AMPEX

MAGNETIC RECORDERS

SERVICE BULLETIN

DATE: 20 March 1953
MODEL: 300
BULLETIN NO: 2
PAGE NO: 1

**PLAYBACK AMPLIFIER
MODEL 300**
AMPEX ELECTRIC CORPORATION
SAN CARLOS, CALIFORNIA

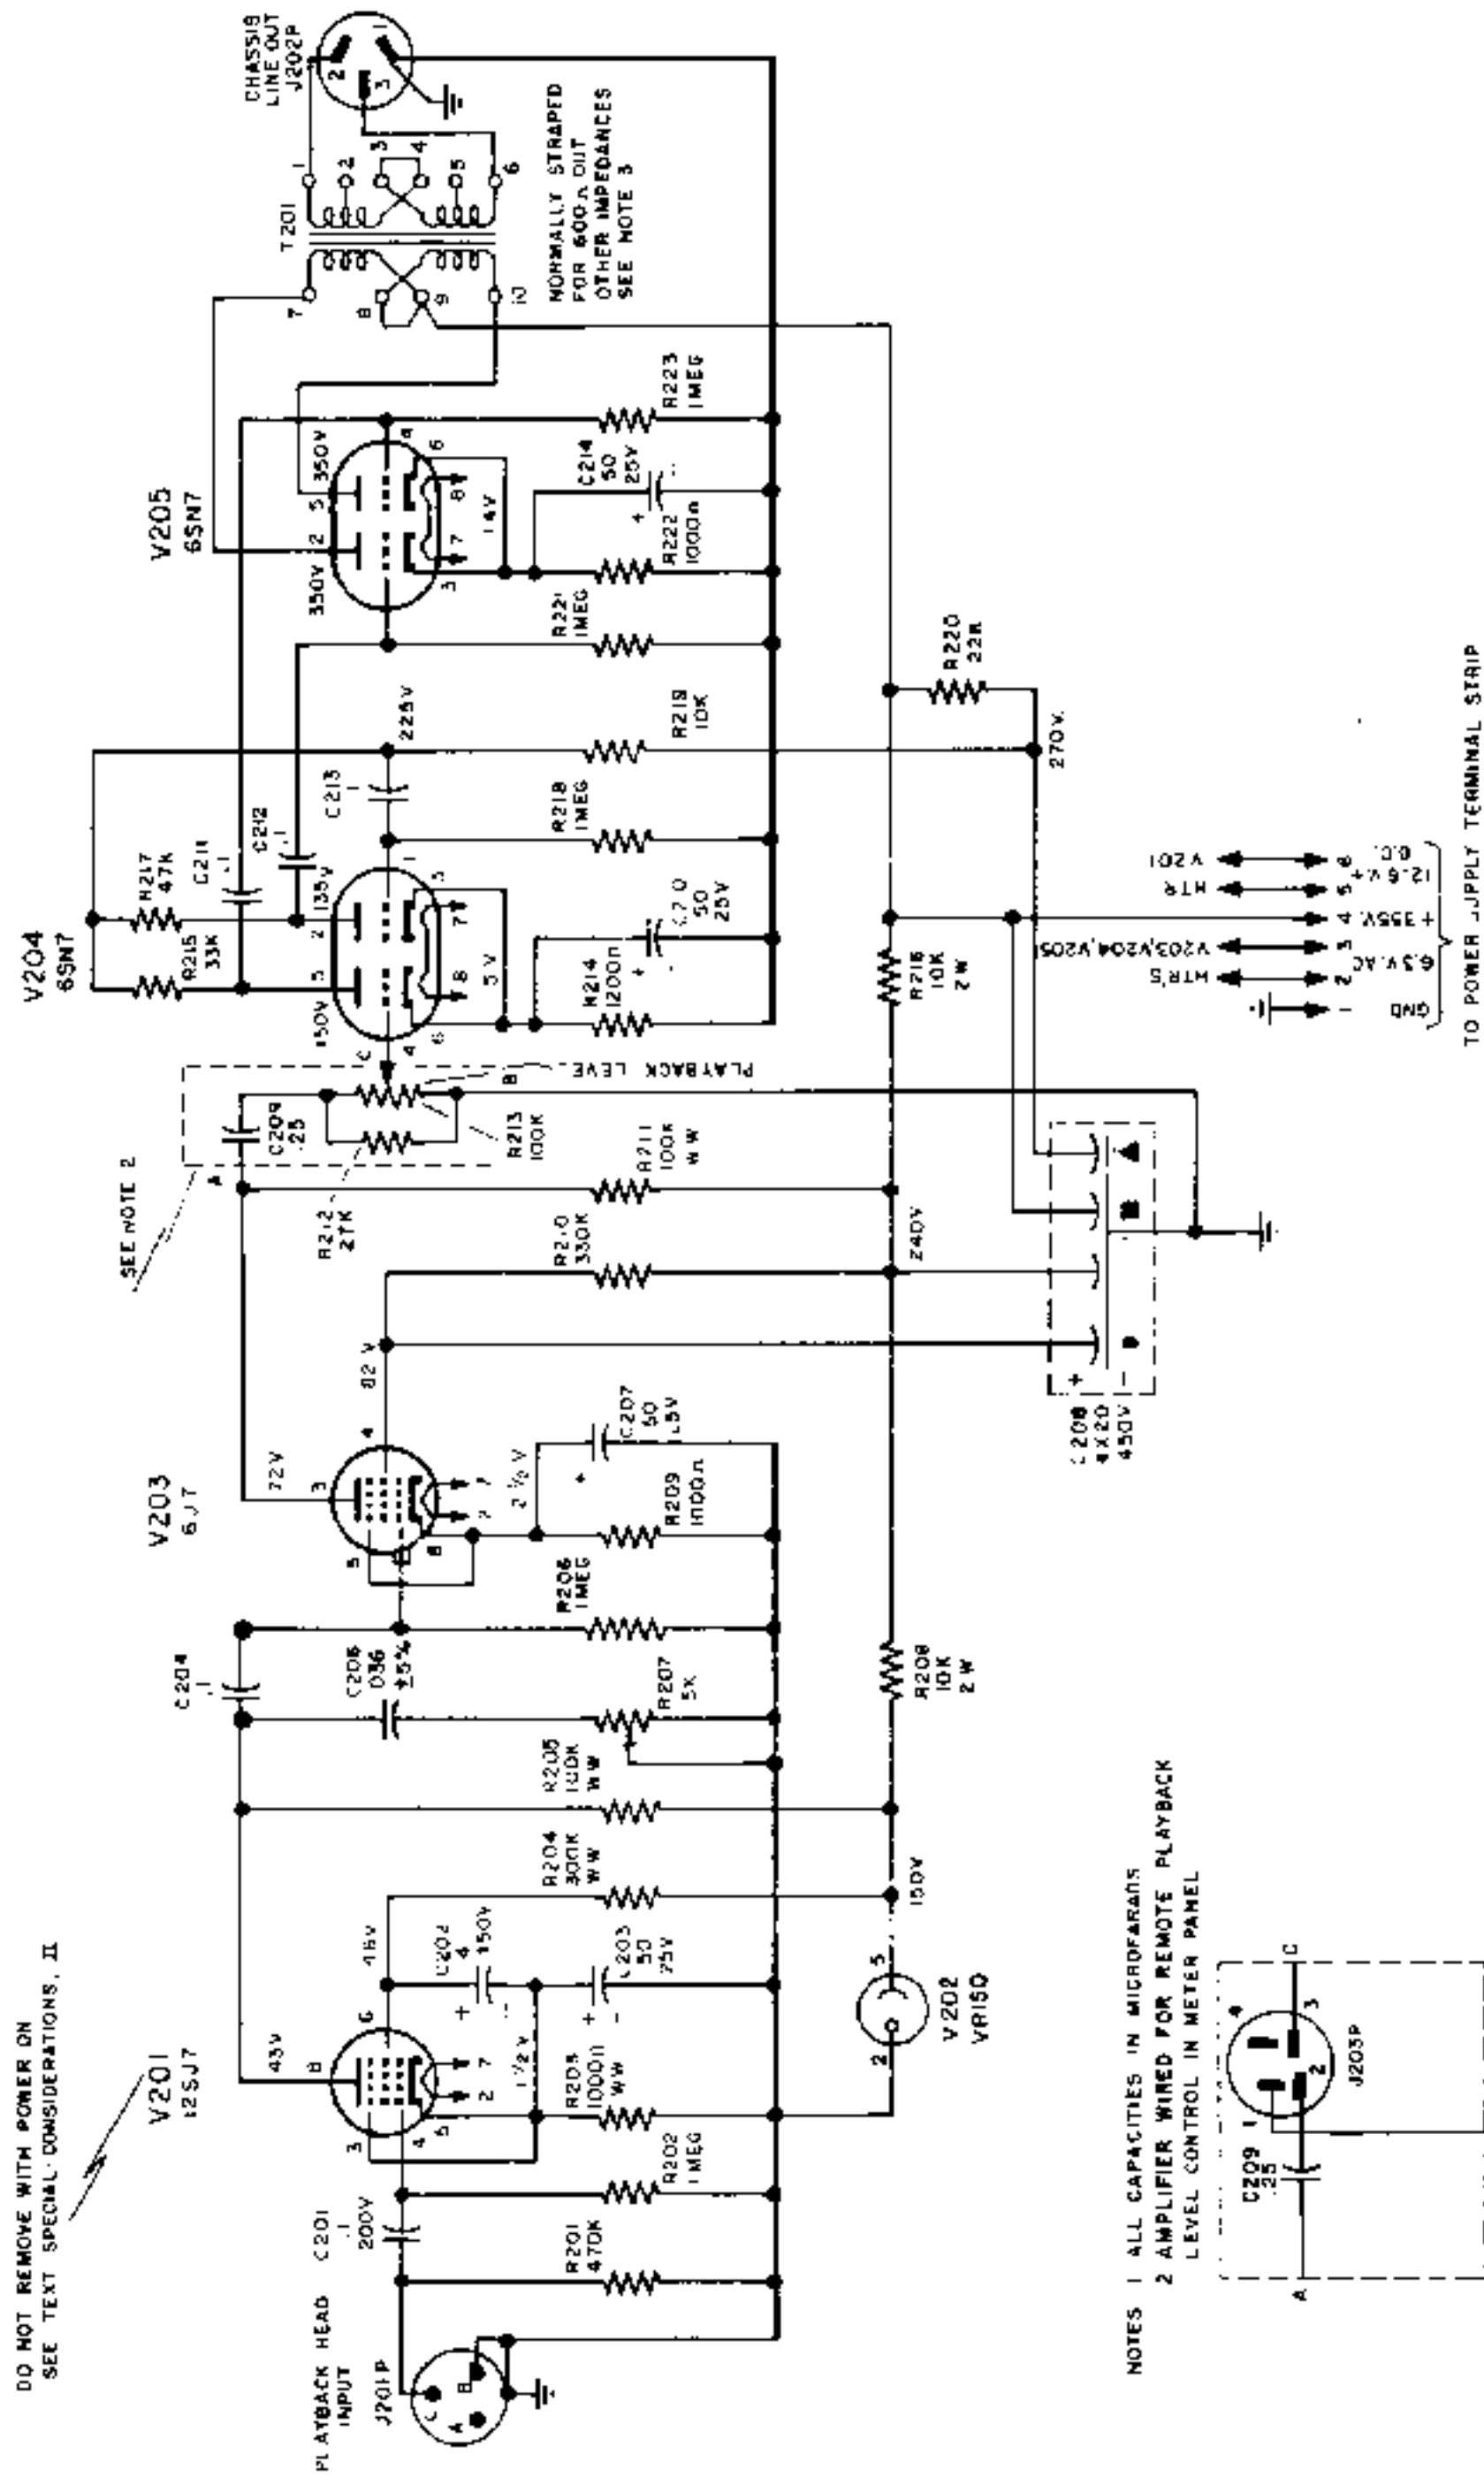
1. The playback equalization circuitry in the grid stage of V203 must be changed to that circuitry shown on the attached playback amplifier diagram. Discard the old R207, 470,000 ohm resistor. The new R207 is a 5,000 ohm potentiometer, Ampex Catalog #RE-273. Discard the old C206, a .006 condenser and substitute the new C206, a .036 condenser, Ampex Catalog #CO-111. Rewire these parts in accordance with the playback amplifier schematic attached.

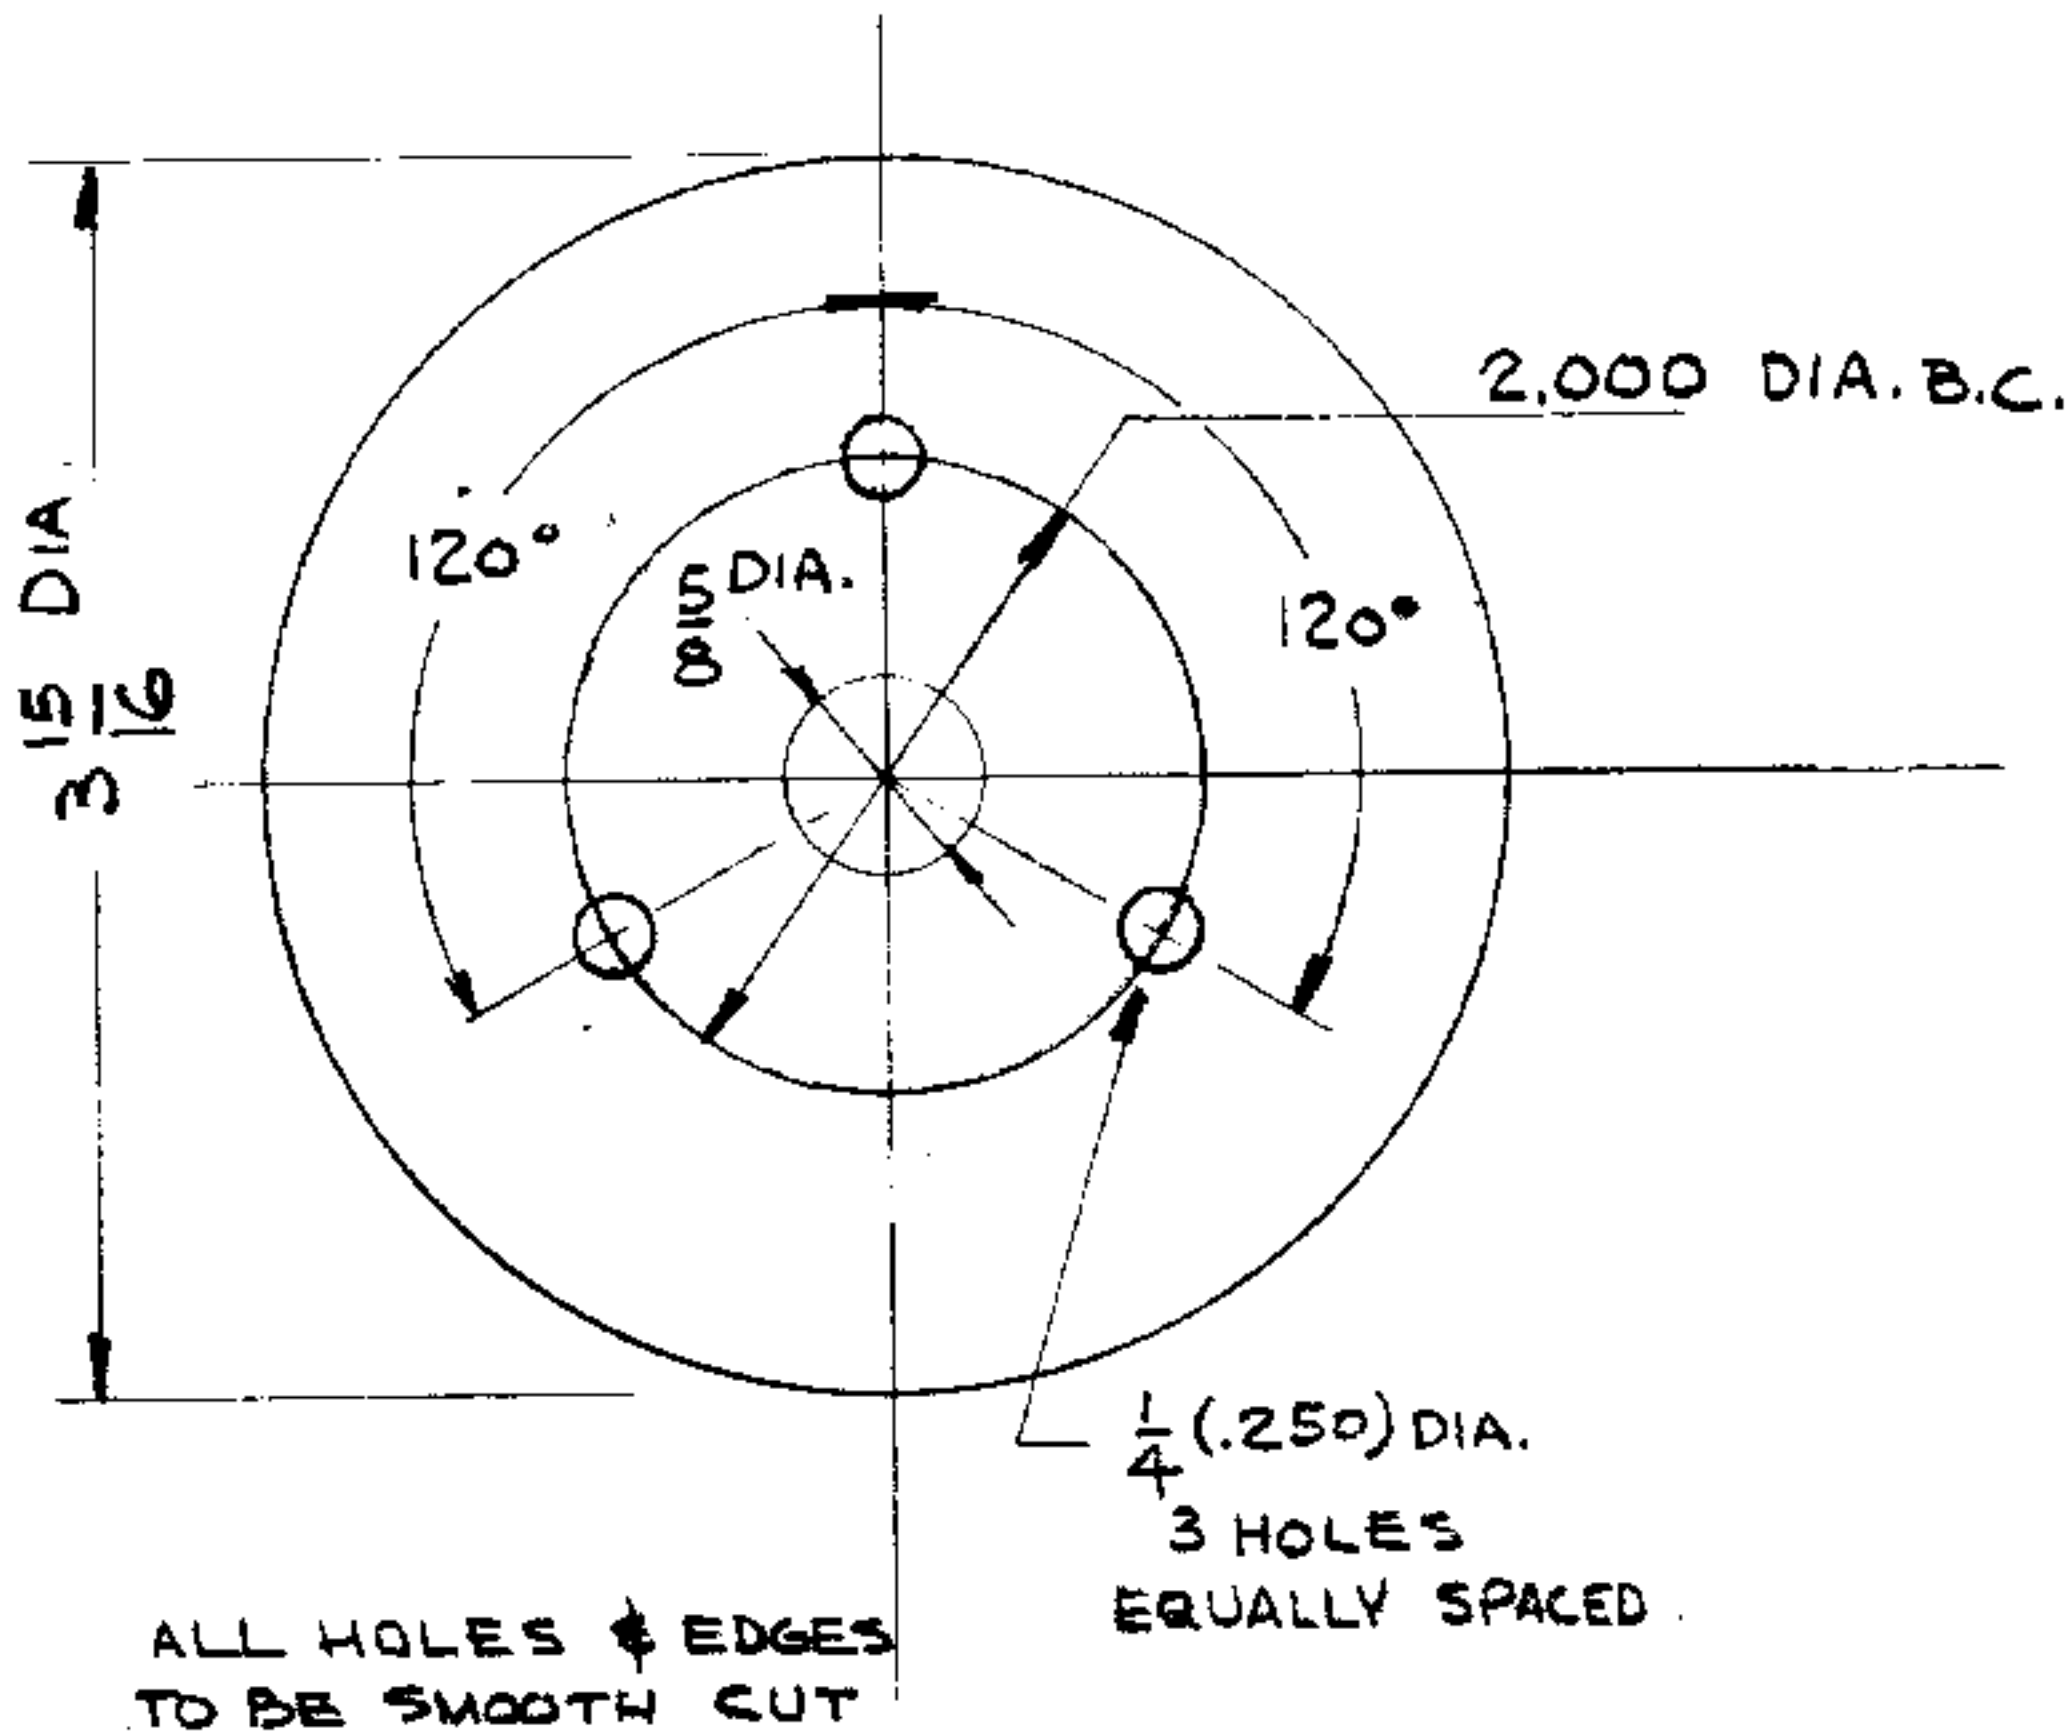
If it is desired to use the new editing knob assemblies, catalog #1917, with a Model 300 recorder which does not have the holes drilled in the turntable, the attached drawing will serve as a template diagram for drilling these holes.

When drilling these holes care should be taken that metal filings do not fall into the end-bell of the turntable motor. This can be accomplished by wrapping a cloth around the end-bell on the under side of the top plate while drilling.
